U. S. NUCLEAR REGULATORY COMMISSION
REGION IV

Inspection Report: 50-382/95-23

Facility Name: Waterford Steam Electric Station, Unit 3

Areas Inspected: A special, announced inspection to review the licensee's corrective actions for the existence of voids in the auxiliary component cooling water (ACCW) system and to review the maintenance and testing for Containment Spray (CS) Valves CS-125A and -125B.

Simplified Elevation View of the CCW/ACCW Systems

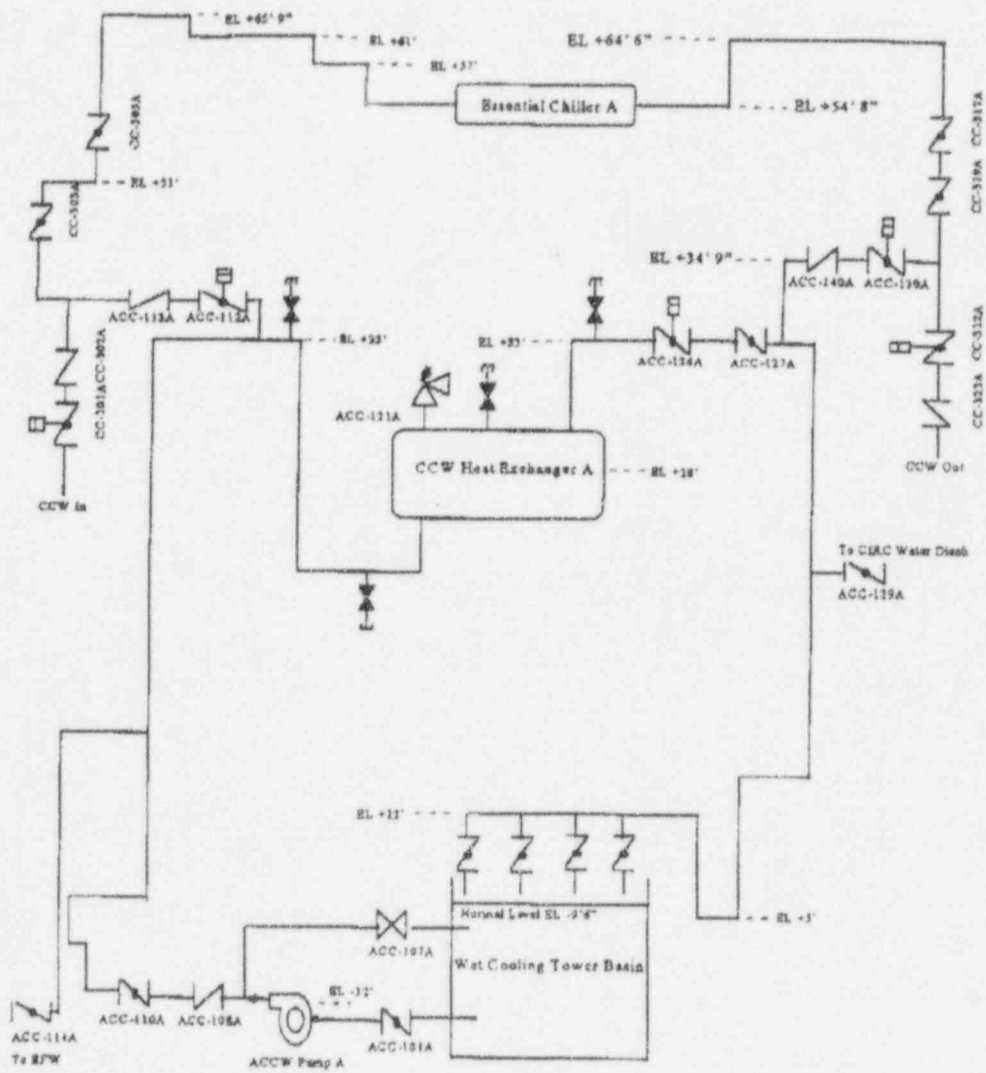
The system is constructed such that an ACCW pump, located at the minus 32-foot elevation, takes a suction from the wet cooling tower basin and discharges the water through the ACCW/CCW heat exchanger, located at the plus 28-foot elevation. After passing through the ACCW/CCW heat exchanger, the water returns to the basin, where it repeats the cycle. See Attachment 2 for a simplified diagram of the system.

The approximately 60-foot elevation difference between the basin and the heat exchanger can cause water to drain out of the system into the basin and can result in the creation of voids in the 16-inch diameter inlet and outlet piping of the heat exchanger. The rate of void creation is dependent on the leak tightness of the upper portions of the system piping and components. The sources of void creation are: (1) air comes out of solution when a vacuum forms in the ACCW system by column separation, (2) air drawn into the ACCW system through leaking valve packing when a vacuum is developed in the ACCW system by column separation or leakage from the system, and (3) air enters the system during maintenance and is not fully vented after the maintenance is completed. The rate of void formation is directly dependent on the extent of the system leakage.

In addition to the creation of voids due to air leaks into the system, voids can also be created by column separation in the approximately 60-foot length of vertical piping from the pump elevation to the heat exchanger elevation. Column separation occurs when water leaks out of the system and there is no source of air to fill the void that is created. As a result, a vacuum is created in the void space. At the bottom of this vertical piping, a pump discharge check valve (Valves ACC-108A and -108B) is installed and the function of the check valve is to ensure that water does not drain from the vertical piping back into the basin and create a void.
